JOB TITLE: **PROPOSED EXTENSION**  
 DRAWING TITLE: **FRONT AND REAR ELEVATIONS**  
 9 THE HEDGEROW - BEARDWOOD - BLACKBURN - BB2 7QU ELEVATIONS - PROPOSED & EXISTING

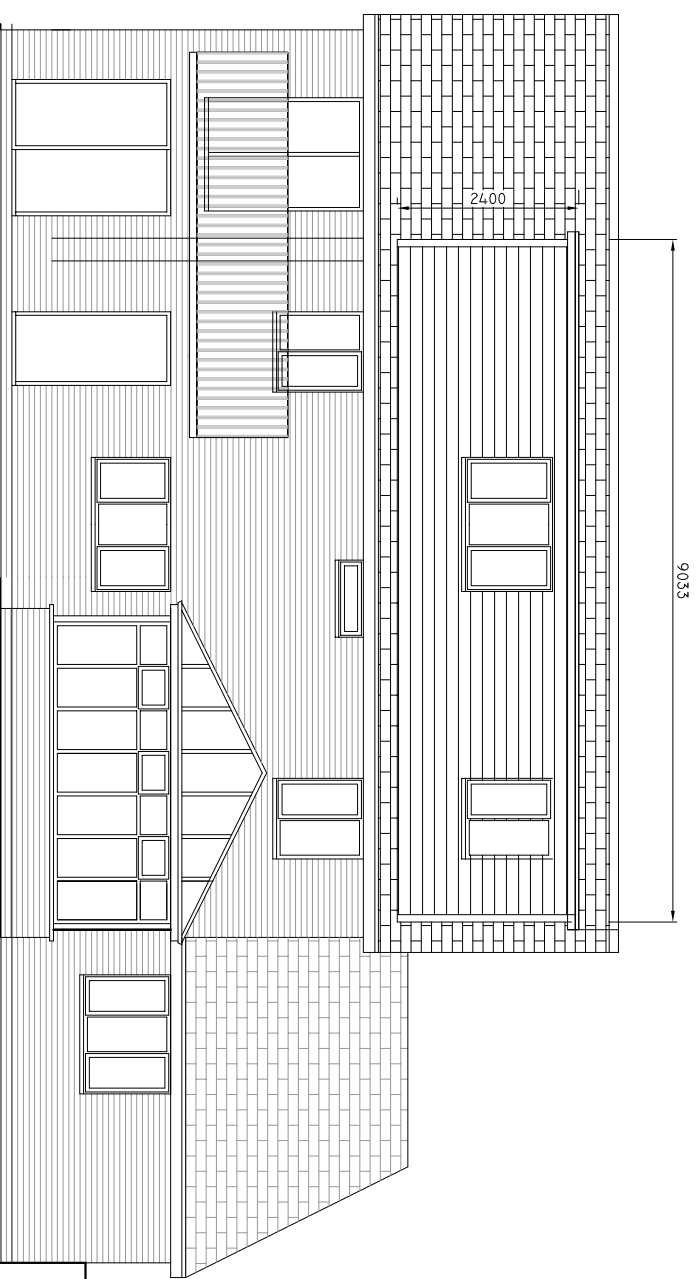
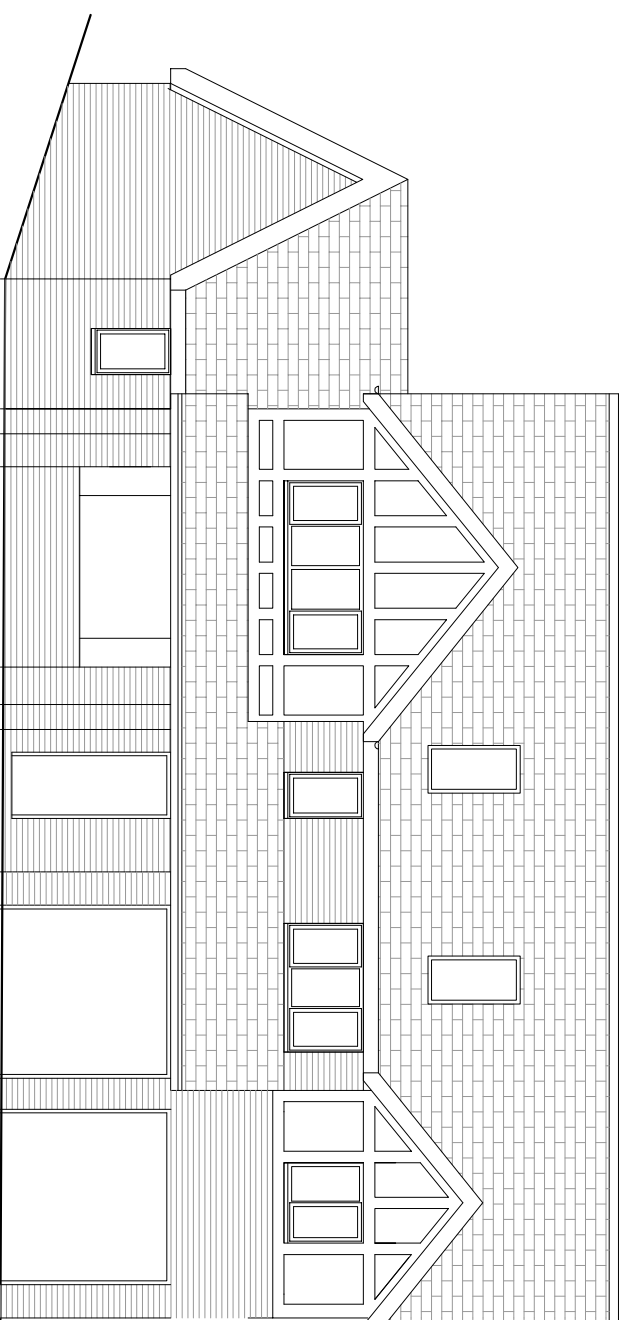
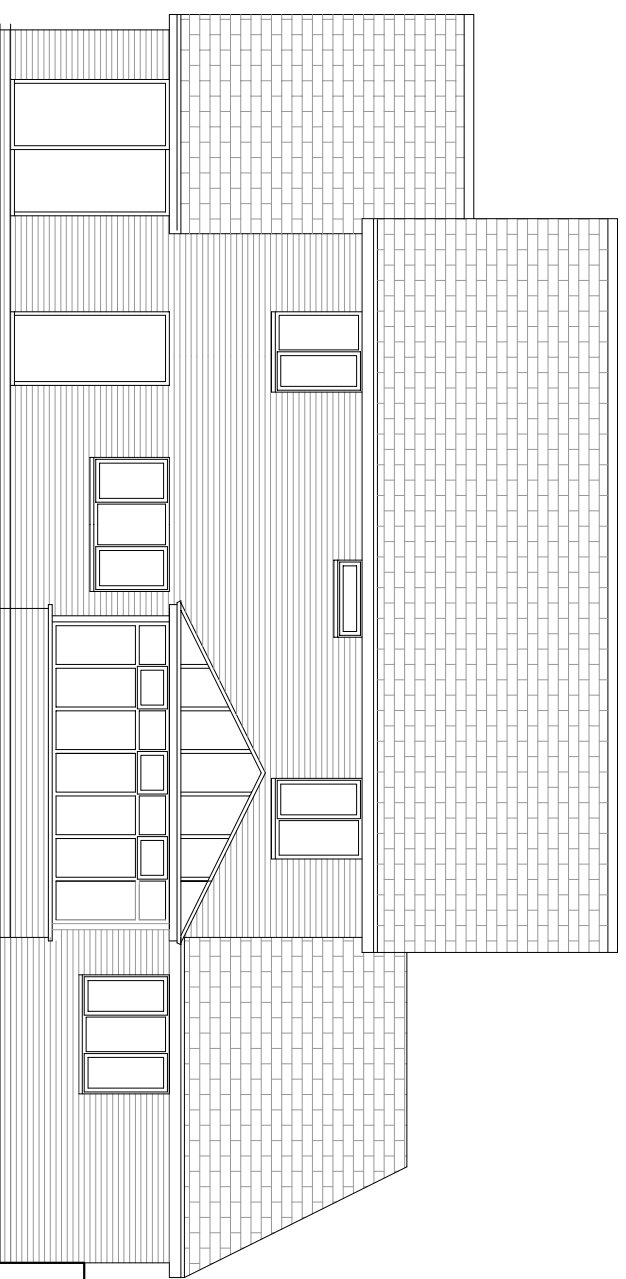
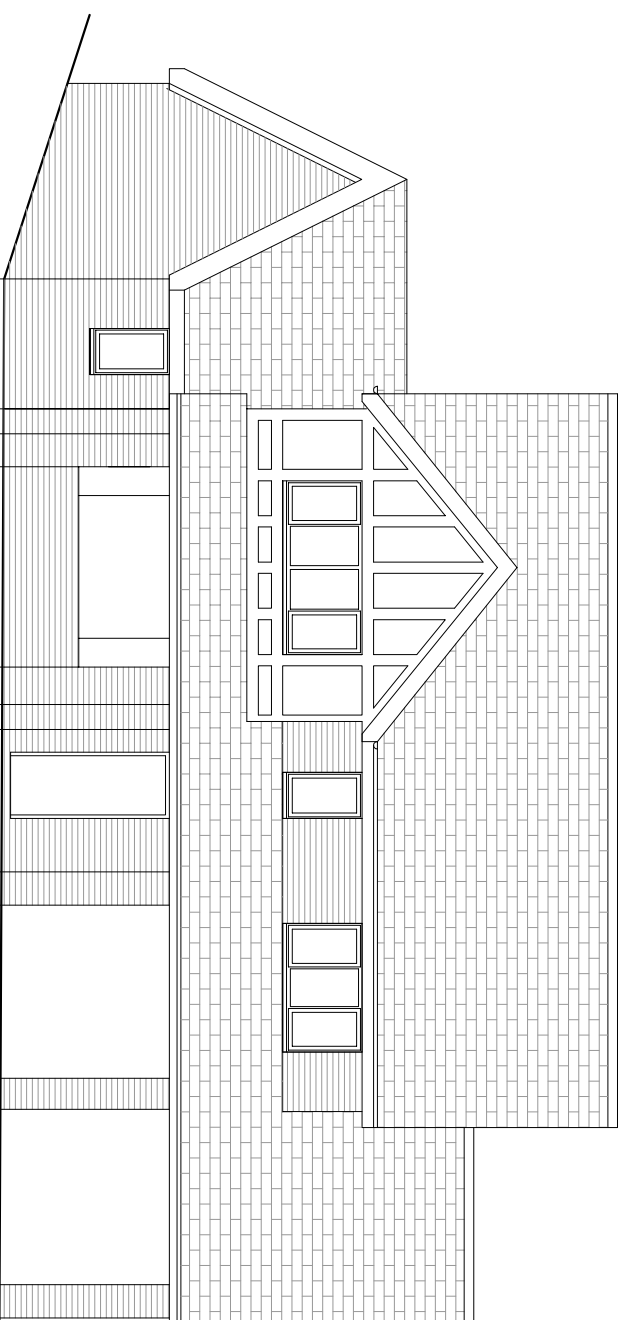
REVISION A - ROOF LIGHTS ADDED 21 SEPTEMBER 2017  
 REVISION B - DORMER ADDED 17 NOV 2017  
 REVISION C - 15-2-18 DORMER SIZE CHANGED SO WITHIN PD GUIDELINES + VELUX ADDED  
 REVISION D - 8TH MARCH 2018 - VELUX REMOVED
